An Assessment of the LNAPL Recovery Operation, Mission Valley Terminal and Off-Site Area, San Diego, California

Submitted to the City of San Diego MVT Working Group

**REVIEW OF OFF-SITE HEALTH RISK ASSESSMENTS
MISSION VALLEY TERMINAL**

**Prepared for:
City Of San Diego**

Figure 1: Location of Proposed Groundwater Supply Wells

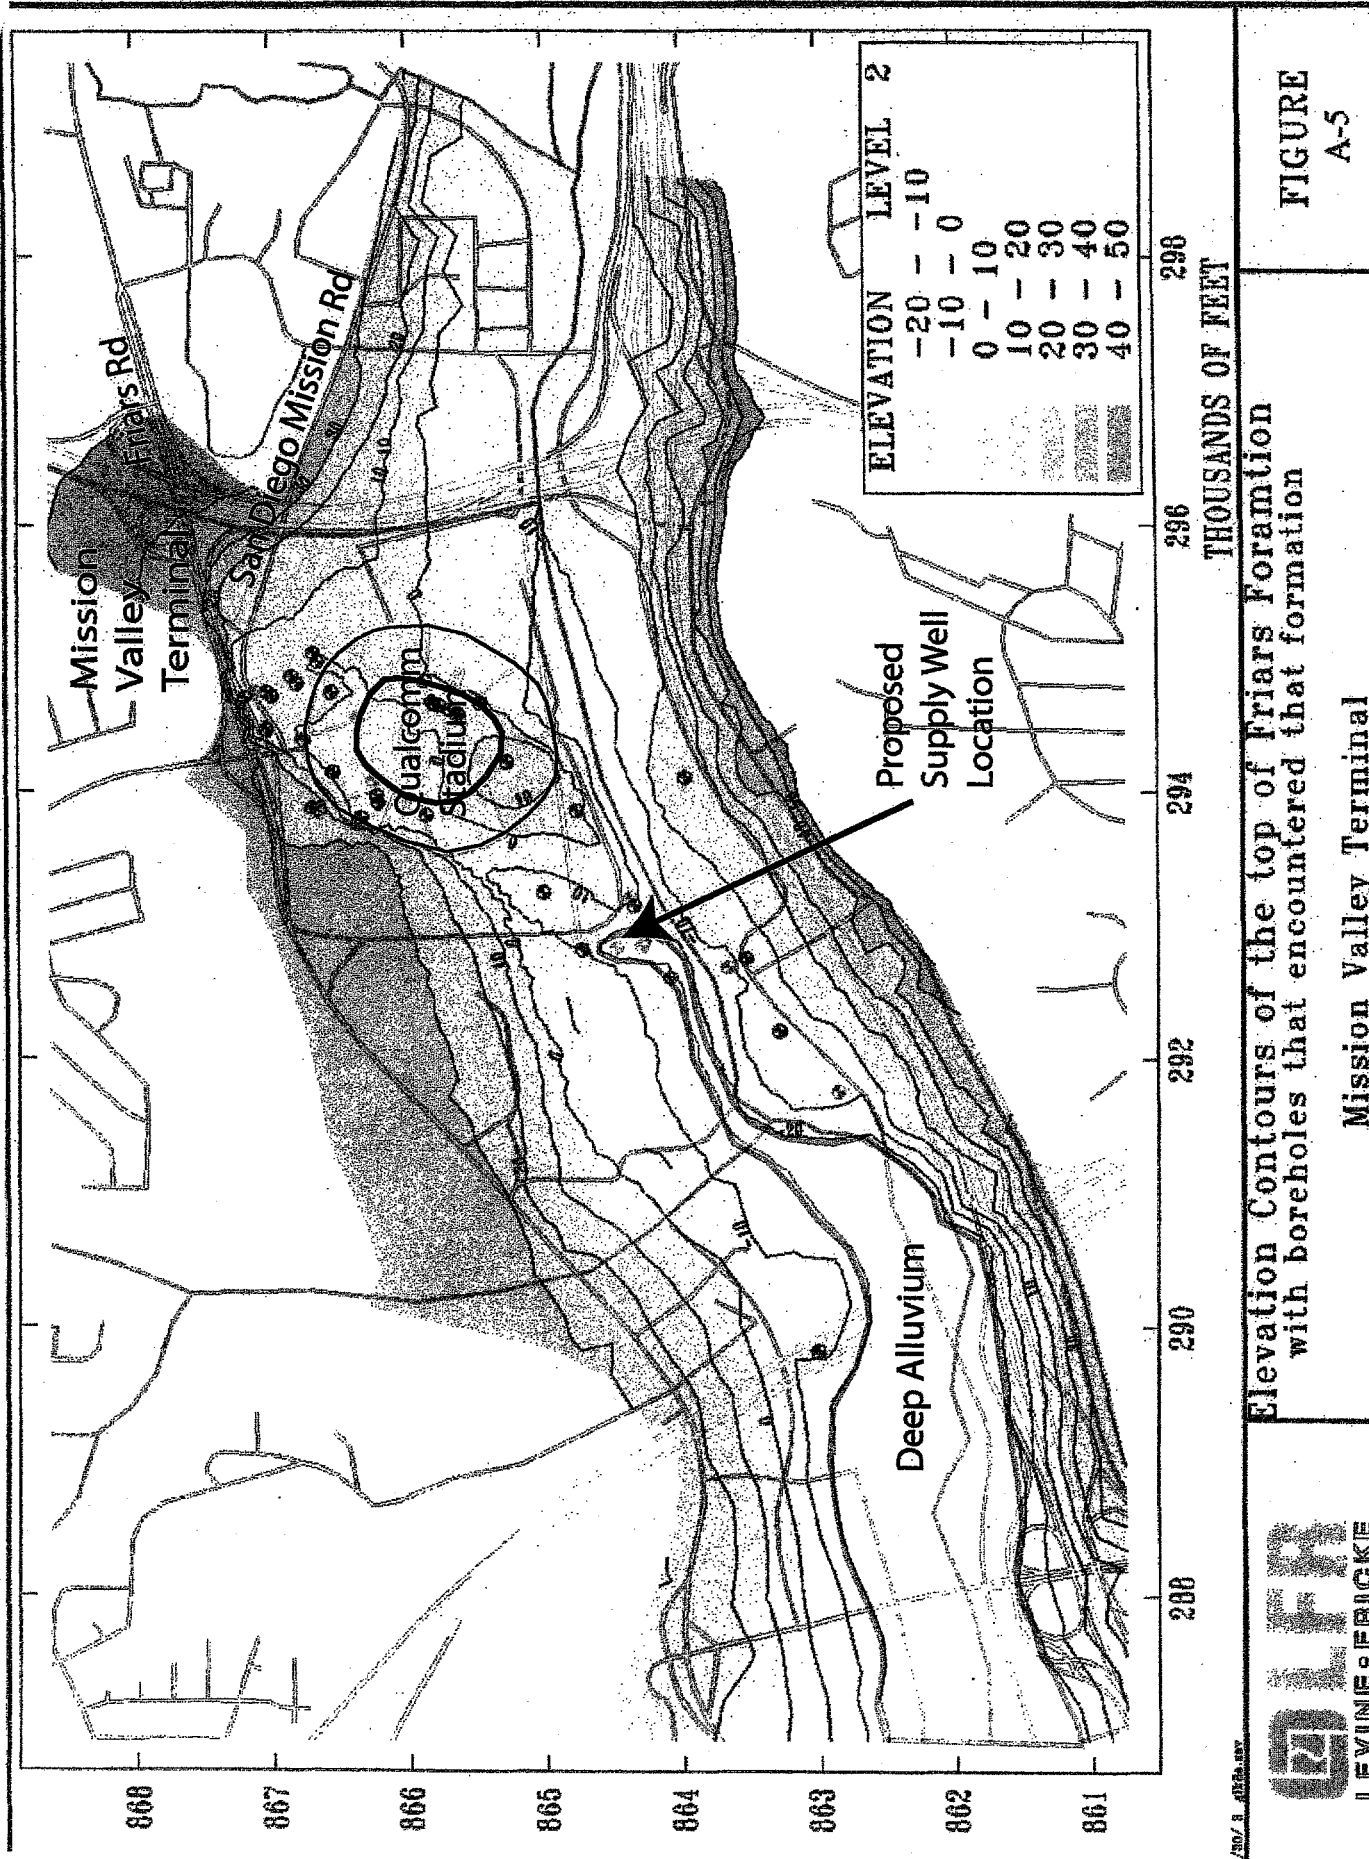
Review of the work done by the Discharger (Summary 2004) shows that the deepest portion of the alluvial sediments occurs along a NE-trending channel, from the San Diego River channel towards the west side Qualcomm Stadium (**Figure 1**). The occurrence of MTBE in groundwater is coincident with the channel, likely a result of preferential flow along the channel. Based upon this initial review, the optimum location for the wellfield would be within the channel given the potential to encounter the deepest portion of alluvium and hence the highest well production rates.

Supplement 2004 presented a mass flux calculation based upon homogenous aquifer conditions and generalized assumptions regarding flow to a wellfield. Prior work conducted by the Discharger included the conduct of a groundwater flow and transport model to evaluate the fate and transport of MTBE within the aquifer. The model explicitly accounted for the change in alluvium thickness as shown by the depth to Friars Formation shown in **Figure 1**. It is recommended that the model be run to evaluate the potential impact of the MTBE on influent concentration to a water supply well field located within the deepest portion of alluvium within the City of San Diego property.
